Agenda
Village of Arlington Heights
Design Commission
Community Room, 3rd floor
Arlington Heights Village Hall, 33 S. Arlington Heights Rd.
October 22, 2019
6:30 PM

MINUTES OF
THE VILLAGE OF ARLINGTON HEIGHTS
DESIGN COMMISSION MEETING
HELD AT THE ARLINGTON HEIGHTS MUNICIPAL BUILDING
33 S. ARLINGTON HEIGHTS RD.
OCTOBER 10, 2019

ITEM 1. SINGLE-FAMILY TEARDOWN RE-REVIEWDC#19-067 – 1614 N. Chestnut Ave.

STAFF RECOMMENDED REVISED GARAGE ROOF - SIDE ELEVATION

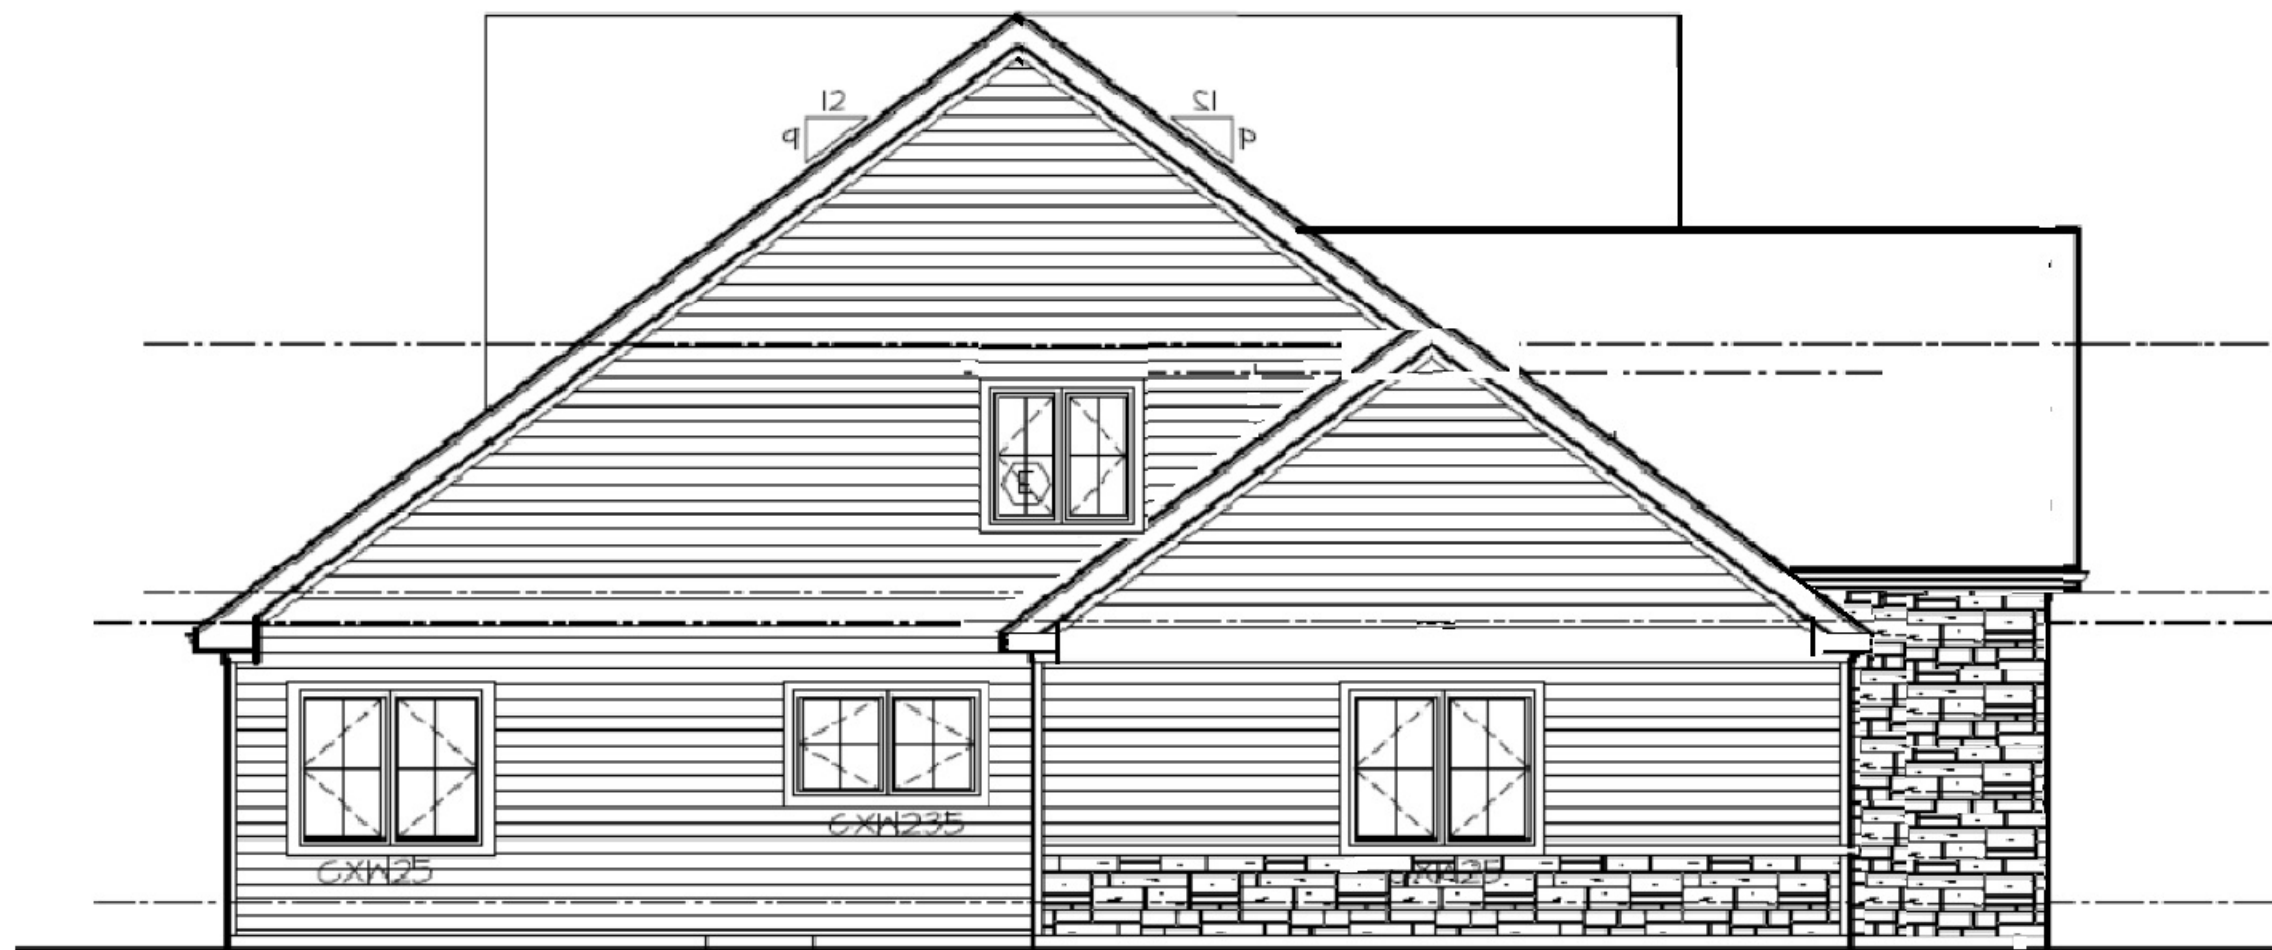
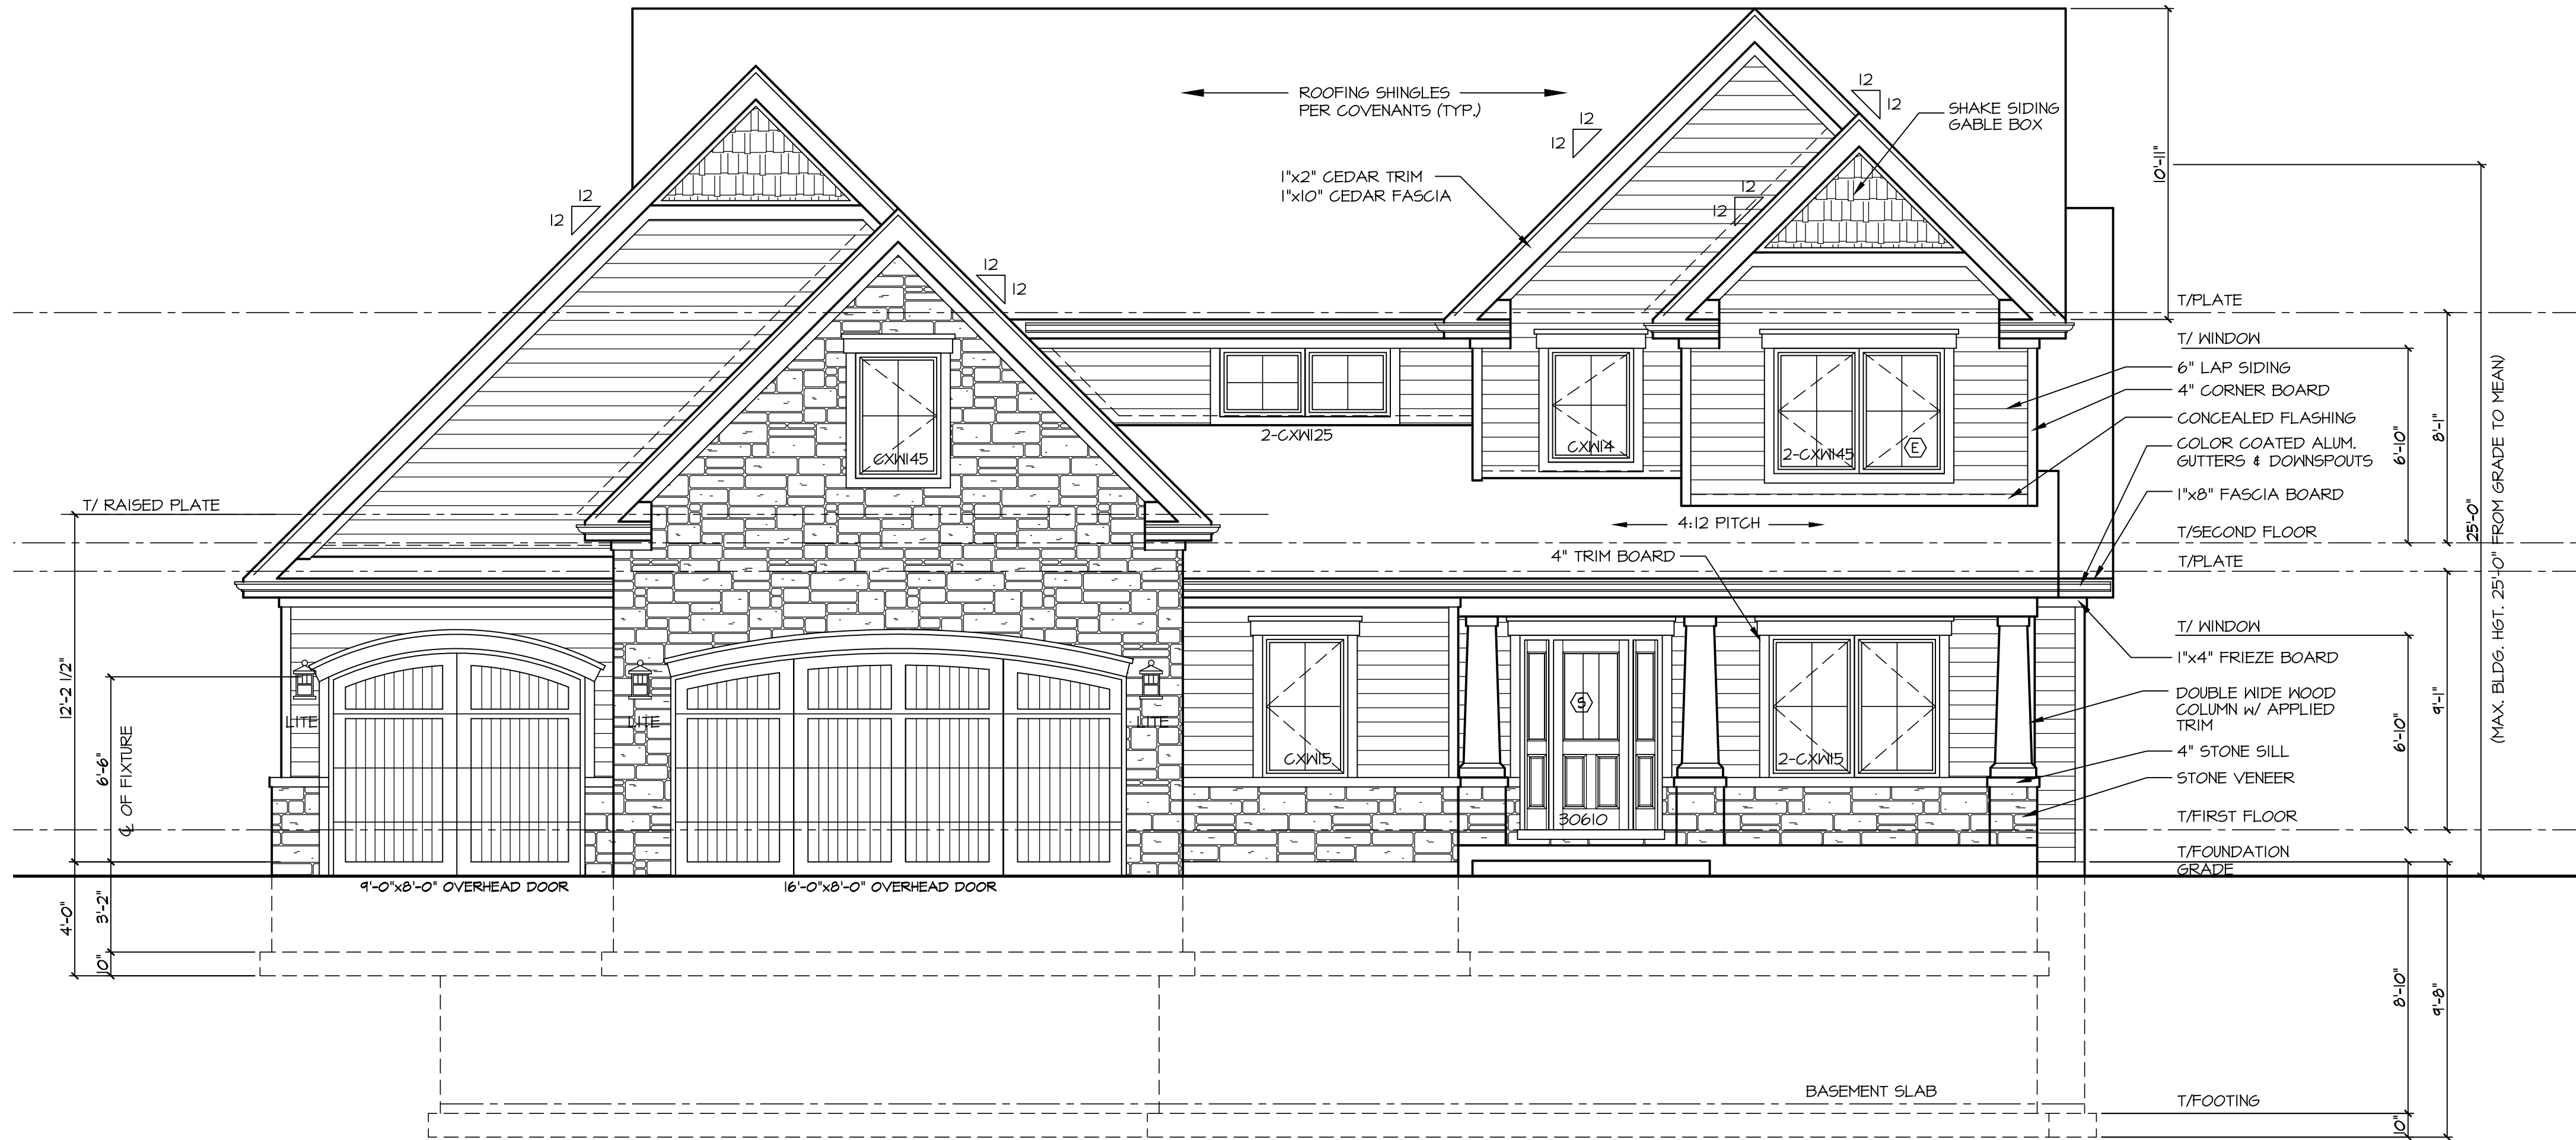
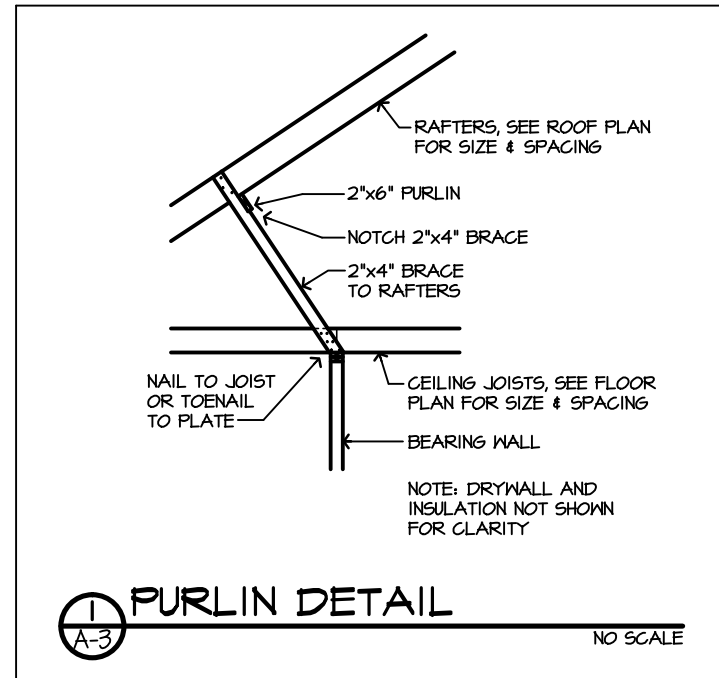
1. A recommendation to change the roof above the third car garage space to a front-to-back gable, framing into the side of the two-car garage.

2. A recommendation to set the third car garage space further back, approximately four feet from the front garage wall to diminish the appearance of the three-car garage.

1. A recommendation to change the roof above the third car garage space to a front-to-back gable, framing into the side of the two-car garage.
2. A recommendation to set the third car garage space further back, approximately four feet from the front garage wall to diminish the appearance of the three-car garage.
